Oakdale West Estate Development Kemps Creek

Civil, Stormwater and Infrastructure Services Report

SSDA 7348 - Modification No. 7

CODE/ REP005-01-15-272

Figure 1 – Precinct 3 – Modification No. 7 earthworks compared to Approved Modification No. 6

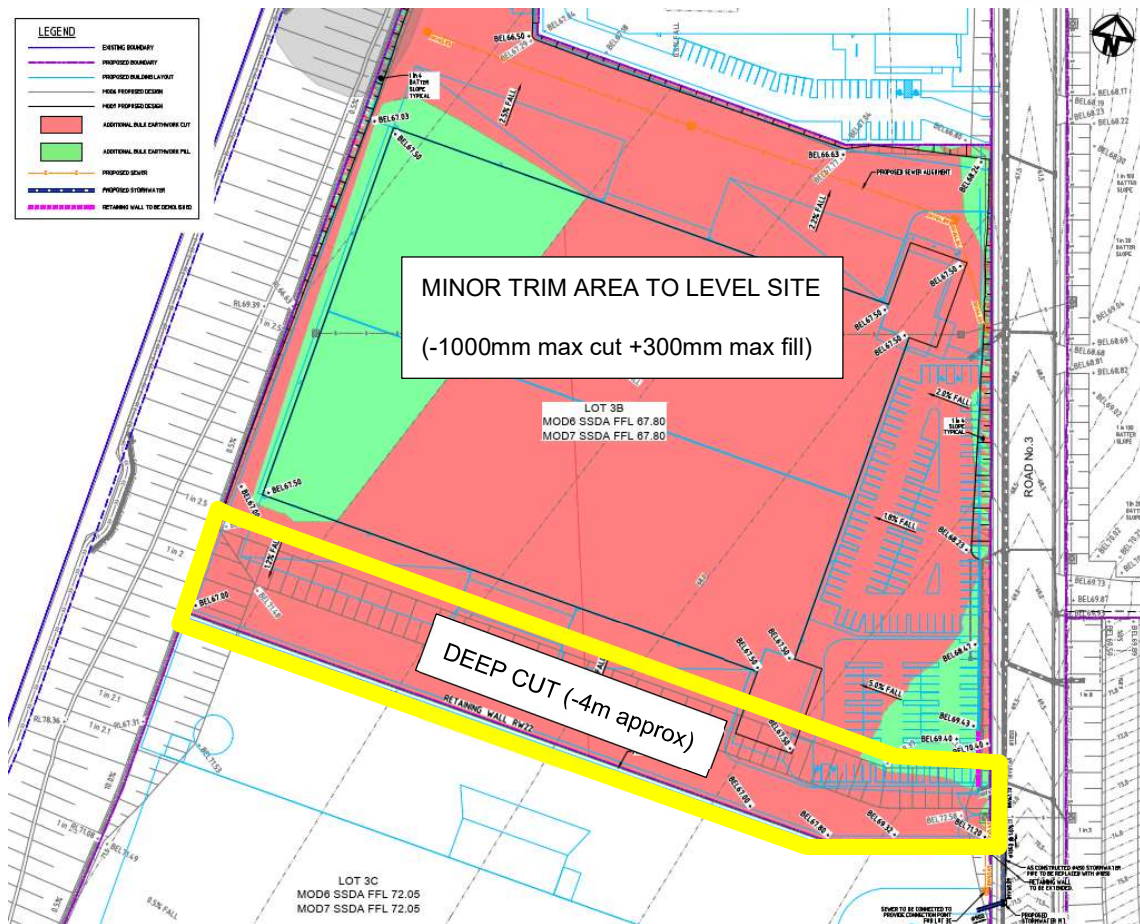
Ultimately the pad levels are unchanged, however are slightly modified to match the change in lot shape. The inclusion of a new retaining wall between Lot 3B and Lot 3C has had further minor affects to the earthworks quantities.

In Precinct 3, the earthworks levels are generally lower than the previously approved design as part of Modification No. 6.

For ease of coordination, a comprehensive Estate-wide set of bulk earthworks drawings have been prepared which are intended to replace the previous Stage 1 approved drawings in Modification No. 6. The changes in earthworks are compared below, so it is possible to see how minor the earthworks surface changes are. It shall be noted that Precinct 3 lots have been generally lowered when compared to the previously approved design as part of Modification 6.

Figure 2 – Precinct 4 – Modification No. 7 earthworks compared to Approved Modification No. 6

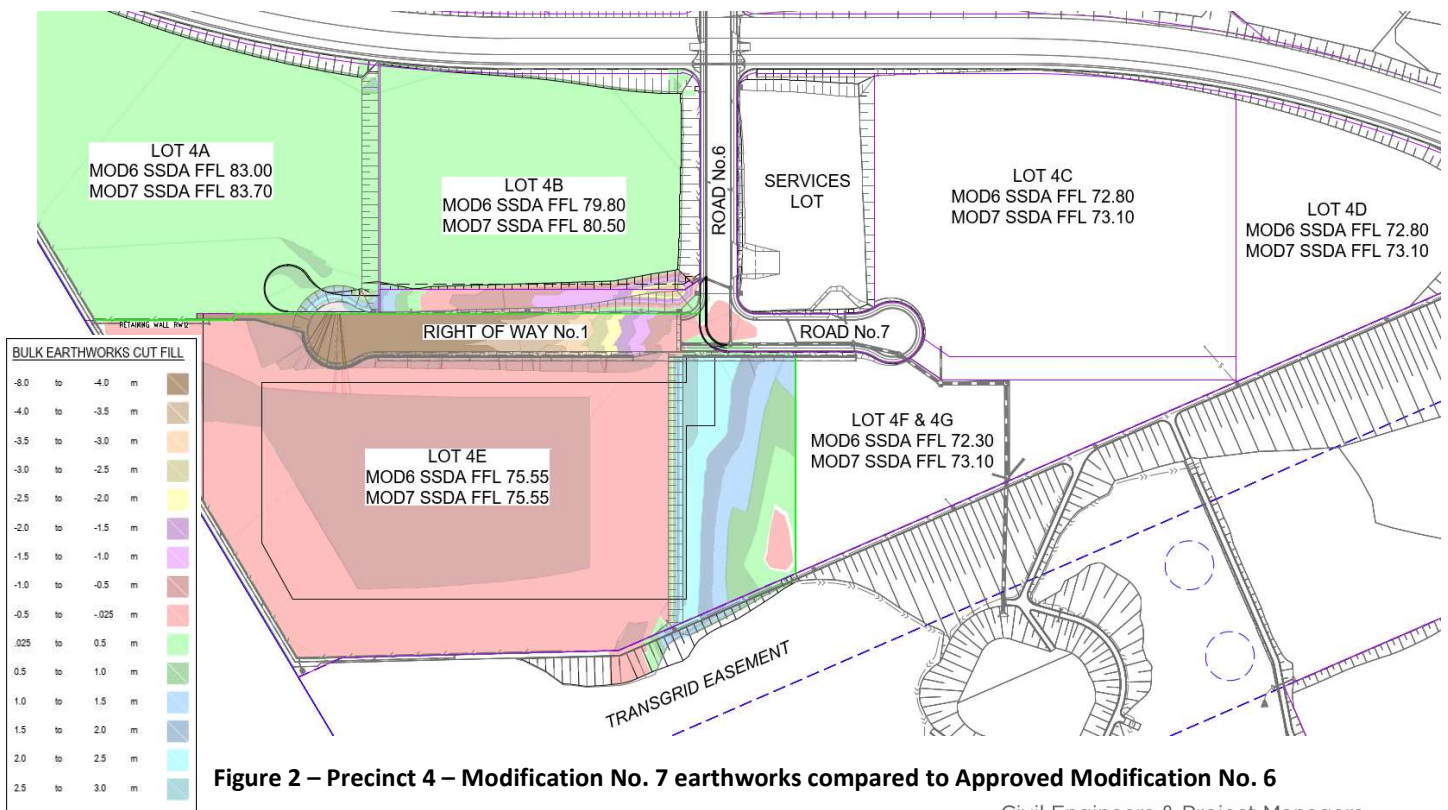
The Precinct 3 and 4 areas are now reconfigured to suit customer needs which is reflected in new lot shape which in turn alters the earthworks slightly. The earthworks design for Modification No. 7 was undertaken using the following considerations:

- Maintain the same or less quantity of import for the project and same nominal Bulk Earthwork Levels (BEL) in Precinct 3;
- Maintain as close as possible the quantity of import and the nominal BEL in Precinct 4;
- Minimise any noticeable changes in the earthworks surface or retaining walls.

Figure 3 – Previously Approved Modification No. 6 Retaining Wall Plan (left) and Modification No. 7 Retaining Wall Plan (right)

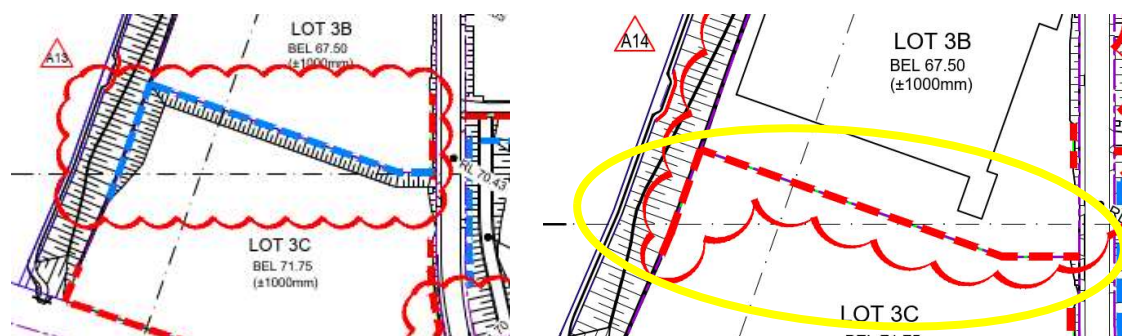
As part of the Stage 1 approved drawings, AT&L nominated that there was to be a future retaining wall to be constructed between Lots 3B and 3C, as shown below as part of the Modification No. 6. Note that future retaining walls are shown in blue, while retaining walls that form part of the Stage 1 approval are shown in red.

This retaining wall is to now be included as part of the Stage 1 approval. The extent of the wall has been adjusted to suit the revised allotment design, with the extent shown below.

Figure 4 – Lot 4E – Previously Approved Modification No. 6 Retaining Wall Plan (left) and Modification No. 7 Retaining Wall Plan (right)

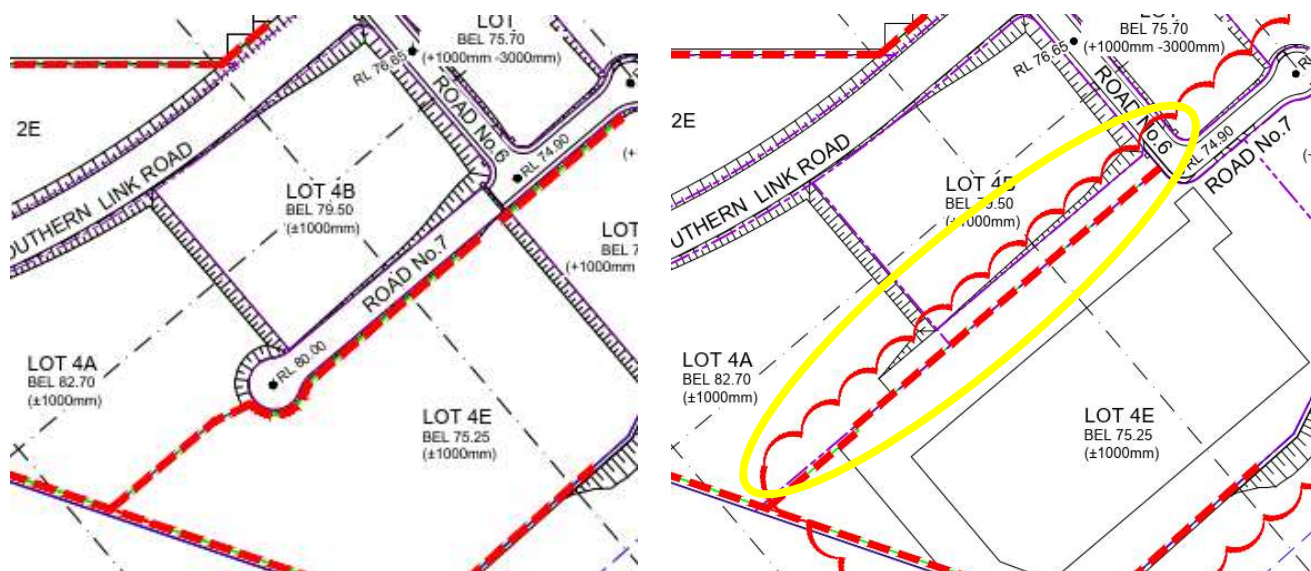
The Stage 1 approved drawings also indicated a proposed retaining wall between Lots 4A/4B and Lot 4E as shown below. This retaining wall has been adjusted to suit the revised allotment layout.

Figure 5 – Modification No. 6 Design of the Road No. 6 and Road No. 7 Intersection (top) and Modification No. 7 Design of the Road No. 6 and Road No. 7 Intersection (bottom)

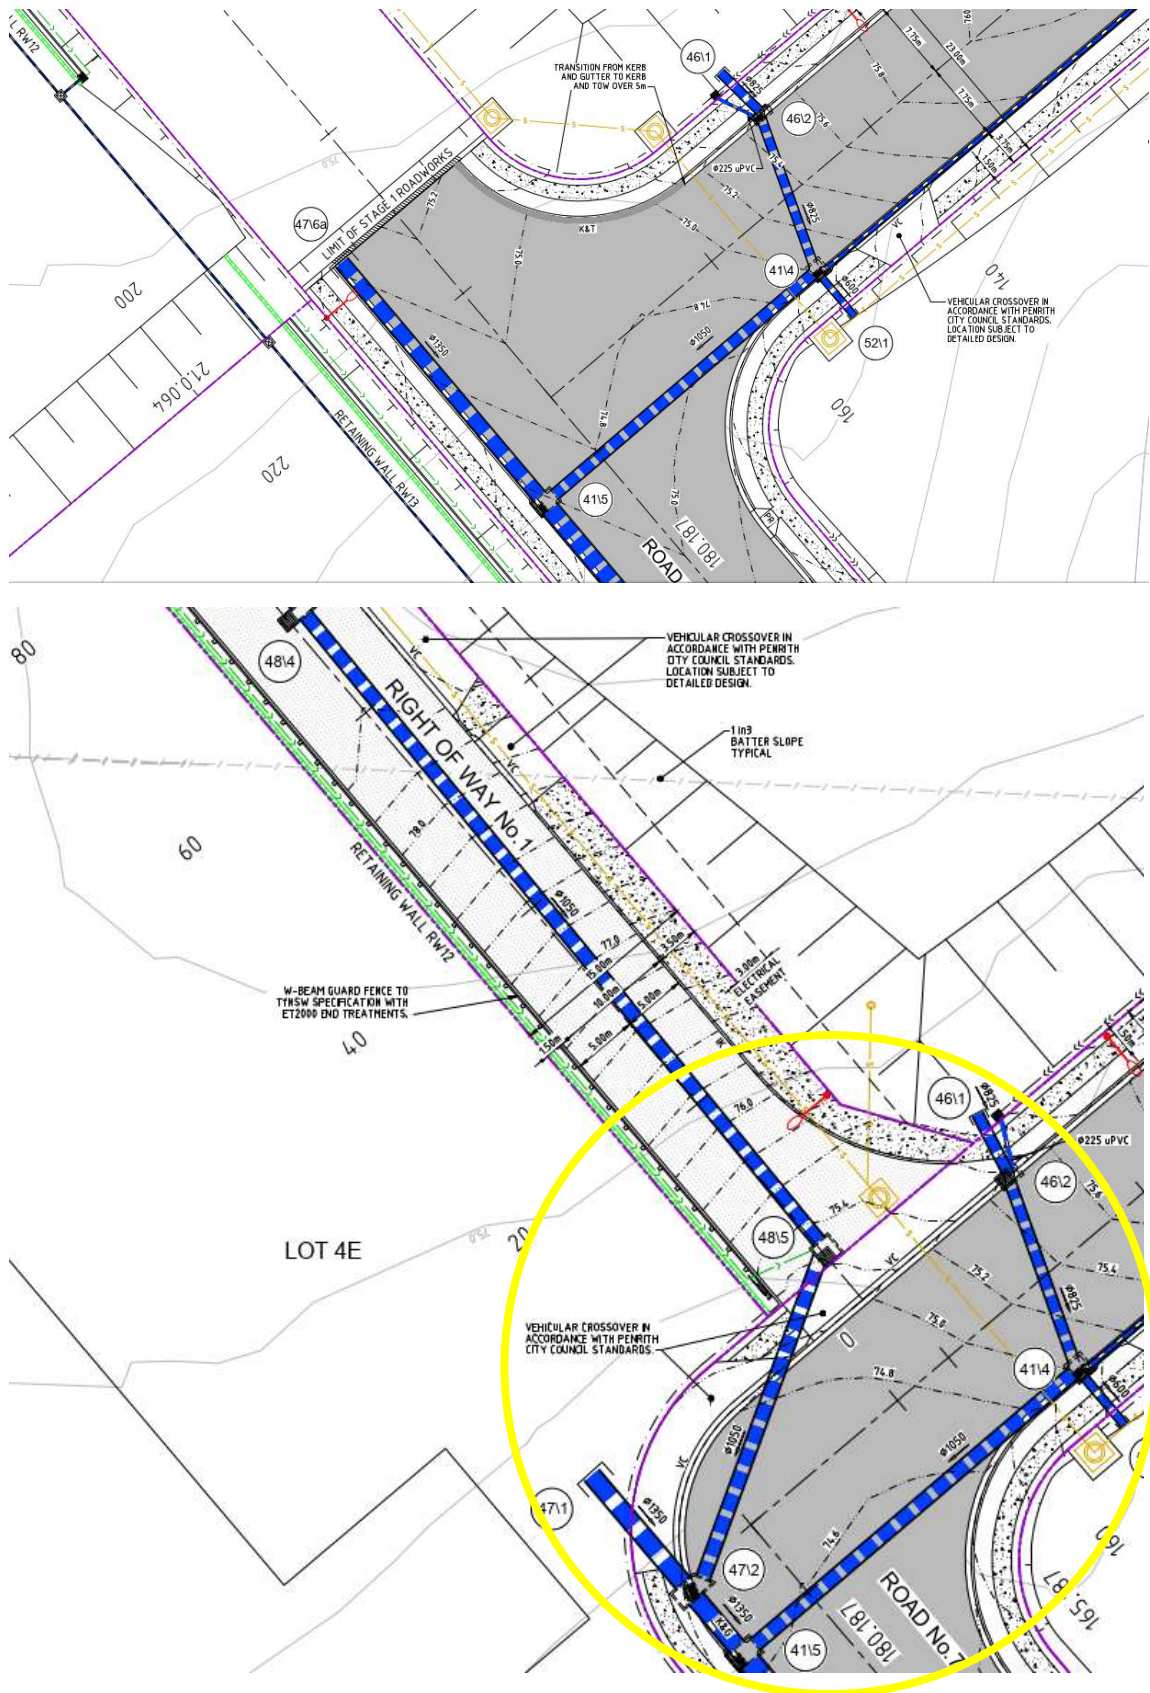
With the changes to the Precinct 4 allotment layout, the future extension of Road 7 towards the south-west is no longer required. As a result, the roadworks at the intersection of Road No. 6 and Road No. 7 have changed.

The previous Stage 1 approved design in Modification No. 6 included the construction of a t-intersection at the intersection of Road No. 6 and Road No. 7. A short section of Road No. 7 was to be constructed toward the south-west as part of the approved design in Modification No. 6. These works are shown below.

The revised road design to suit the changed allotment layout in Precinct 4 includes the complete removal of future Road No. 7 headed south-west, with the intersection of Road No 6 and Road No. 7 adjusted to a change of direction only, such that there is no intersection.

Future access to Lot 4A is proposed to now occur via a Right of Way at allows flexibility for both Lot 4B to utilise for access also. The private driveway will be constructed now as part of Stage 1 infrastructure works.

Figure 6 – Modification No. 6 Batters from Lot 4E and Lot 4F/4G (top) and Modification No. 7 Batters from Lot 4E and Lot 4F/4G (bottom)

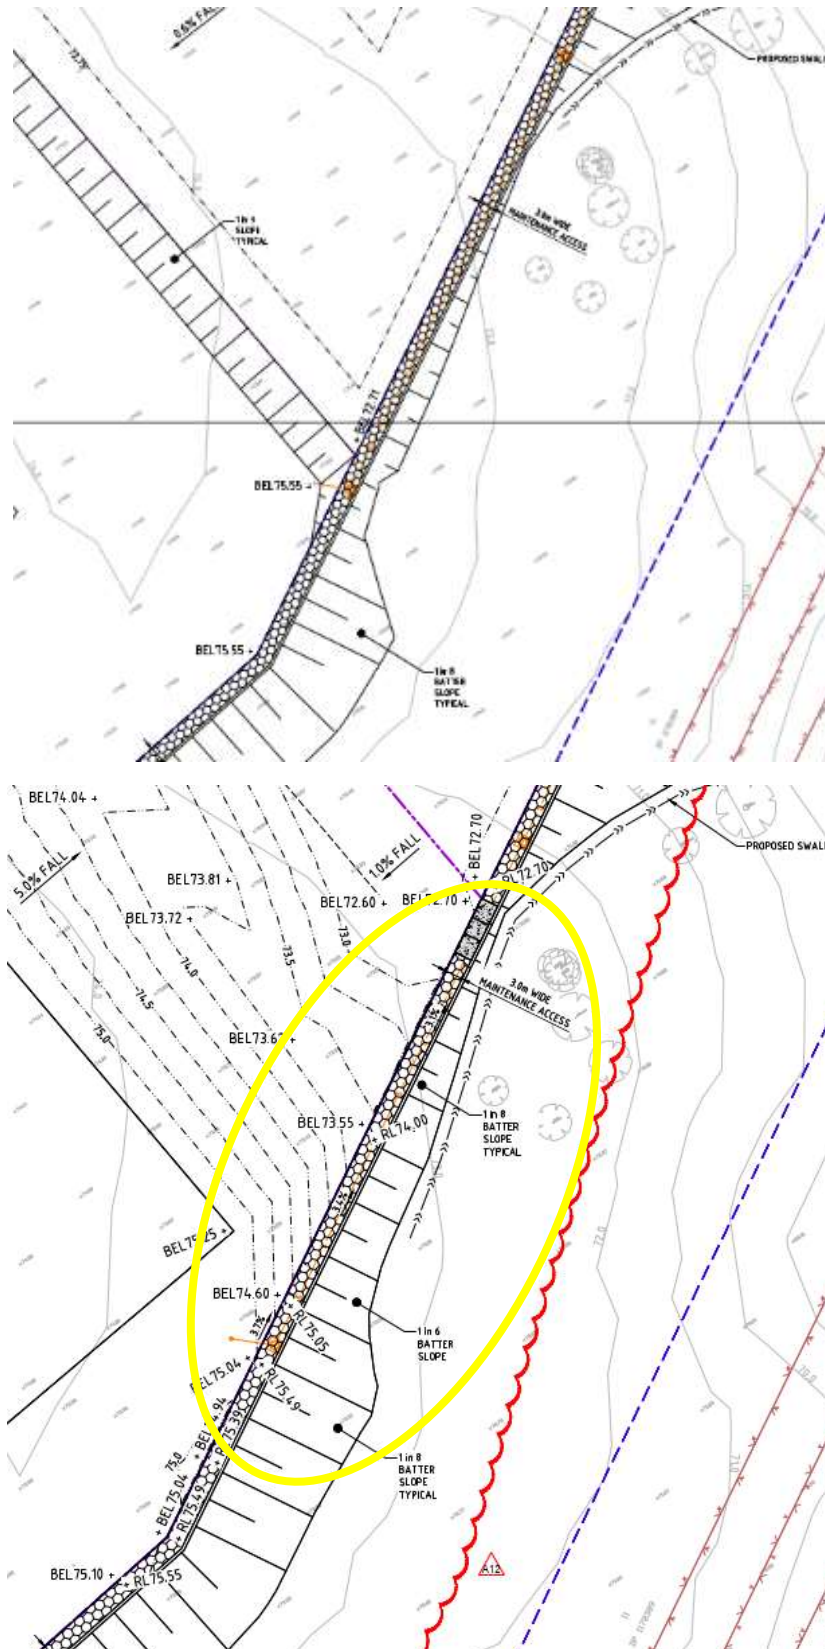
The revised allotment design within Precinct 4, notably to Lot 4E, has resulted in very minor changes to works proposed within the adjacent TransGrid easement.

The minor changes only relate to the extent of battering within the TransGrid Easement, with the affected batters proposed to maintain the maximum 1 in 8 batter slope as per the approved Modification No. 6 design. It is noted that TransGrid's design guidelines have now changed allowing batters as steep as 1 in 6, however we have maintained the 1 in 8 batter slope where possible to provide the best outcome for TransGrid's future use of the empty easement. The changes to the batters are compared below.
